**Explanation of Significant Difference (ESD) for the A-
Area Burning/Rubble Pits (731-A/1A) and Rubble Pit
(731-2A) (ABRP) (U)**

WSRC-RP-2001-4281

Revision 1

April 2002

Figure 1. Map Showing ABRP OU Subunits, M-Area Aquifer TCE Plume, Monitoring Wells, and Remediation Systems

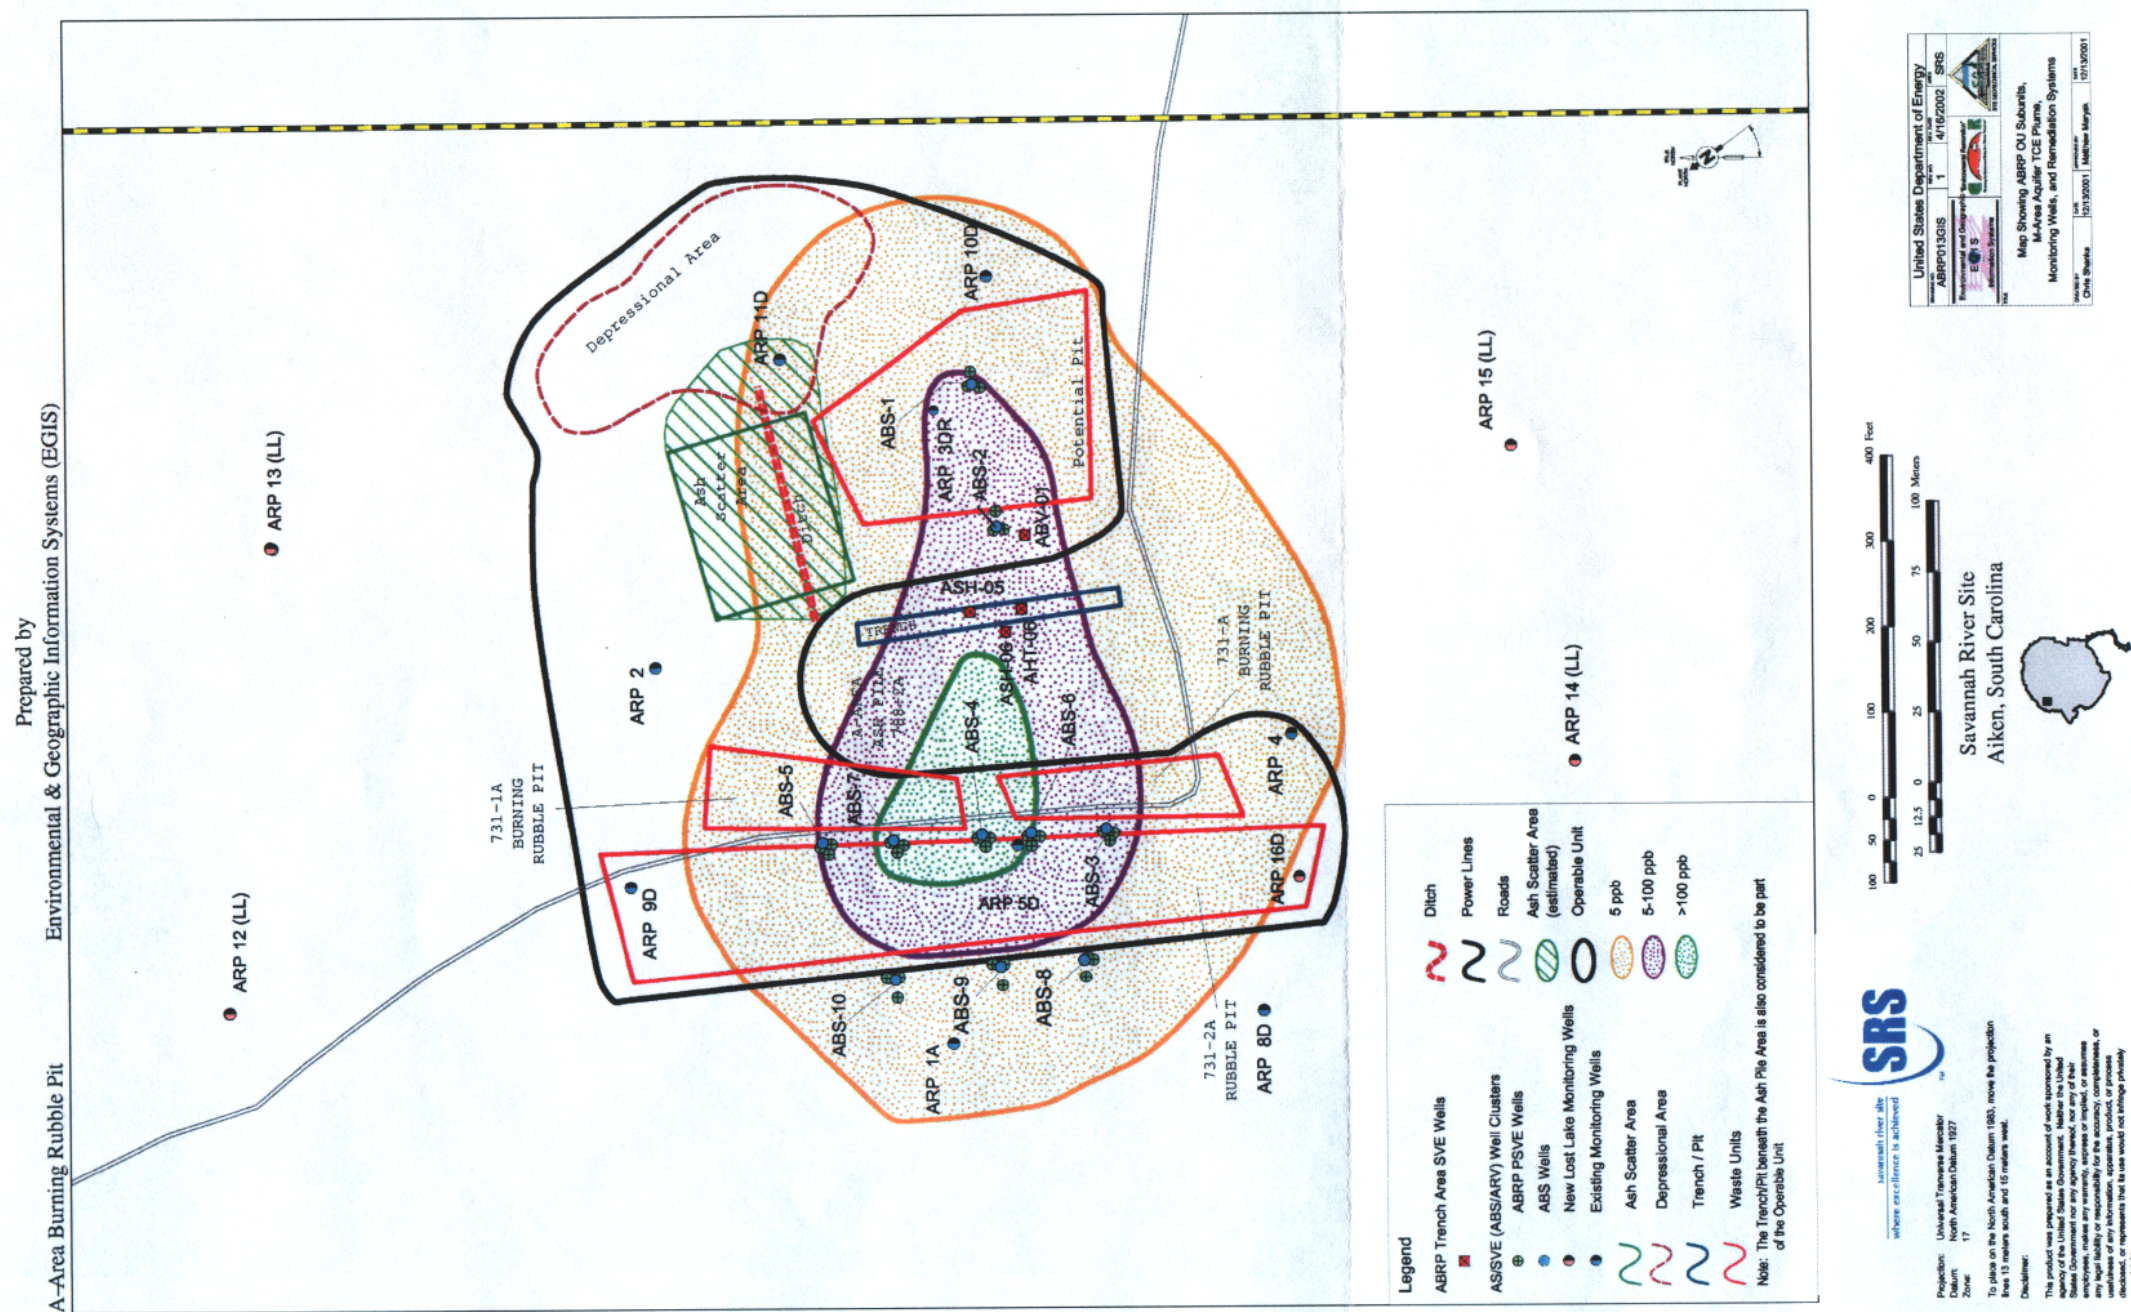
The purpose of this ESD is to document a Post-IROD change to the remedy selected for the ABRP. The significant difference from the original remedy is to operate four new SVE wells in the "trench/pit area" (ASH-06, AHT-05, AHT-06, and ABV-01) as shown in Figure 1 to remediate vadose zone contamination [TCE, PCE, and 1,2-dichloroethylene (1,2-DCE)] which has been determined to be at levels which would leach to groundwater above MCLs. As

The significant difference of the modified remedy from the original remedy is to operate the additional four SVE wells in the trench area to remediate vadose zone contamination (TCE, PCE, and 1,2-DCE) present at levels which would leach to groundwater above MCLs (See Figure 1).

The four trench area wells (ASH-06, AHT-05, AHT-06, and ABV-01) will be evaluated and tested, as necessary, for application of microblowers which are a promising non-passive extraction method. These microblowers will connect directly to the wellhead. The blowers will operate during daylight hours when there is enough solar energy available to supply the necessary power. At other time, the wells will operate passively with a check valve. The effectiveness of the microblower will depend on the permeability of the screened sediments for each well. Hence, if the permeability of the sediments limits the performance of the microblower for a particular well, that well will be operated in a passive mode (with a check valve) only. The operation of SVE wells in the trench area is a modification from the original groundwater AS/SVE remedy because the four new SVE wells target VOC contamination present in the vadose zone. The original ten
